# Intel<sup>®</sup> I/O Controller Hub 10 (Intel<sup>®</sup> ICH 10) Family

Specification Update

*September 2013*

Figure 2-1. Intel® ICH 10 Interface Signals Block Diagram

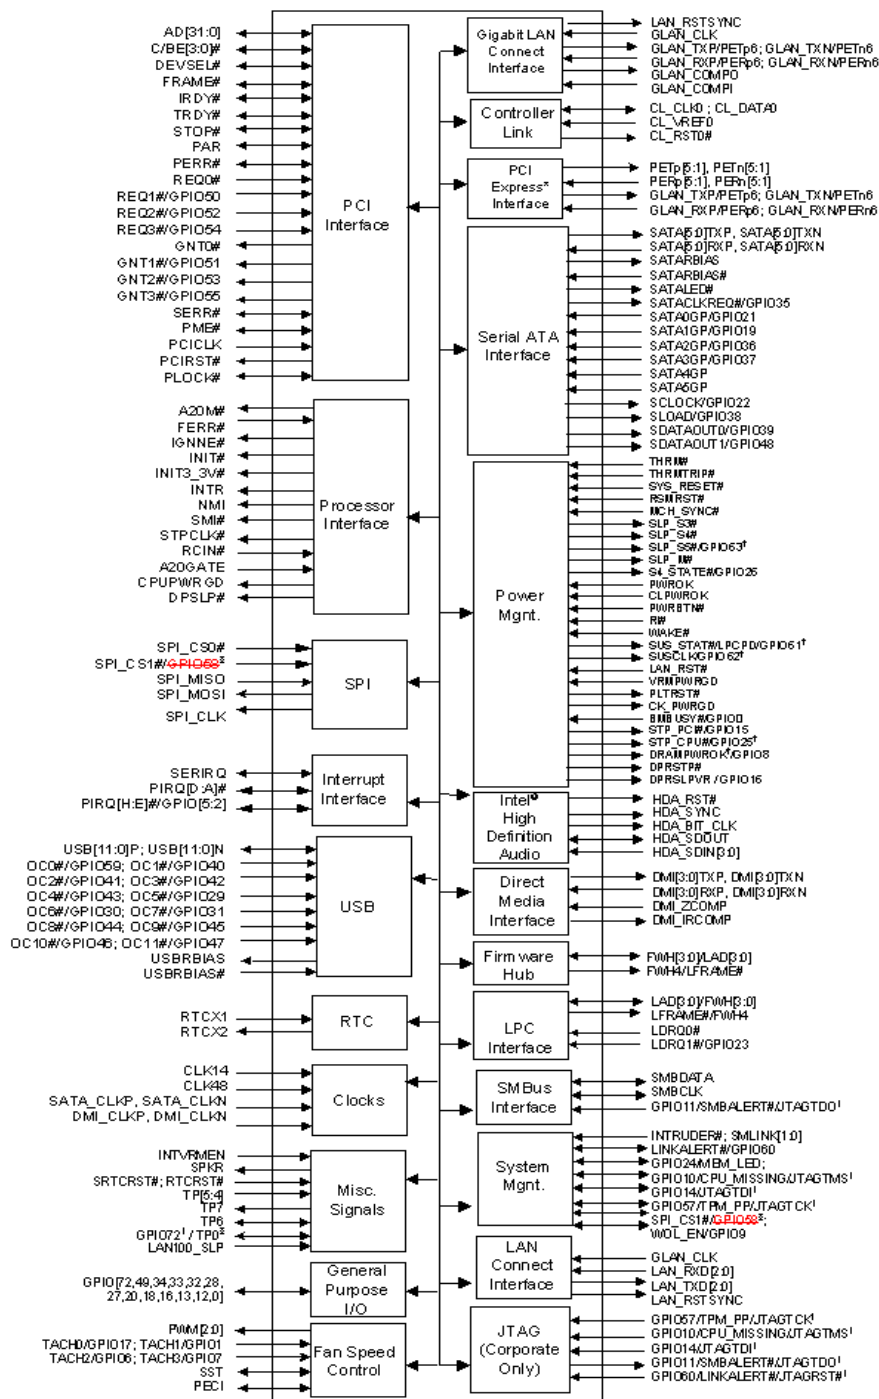
### 9. Remove GPIO58 from Figure 2-1, Intel® ICH 10 Interface Signals Block Diagram

Update the following block diagram in Section 2, Signal Description, in the Datasheet.
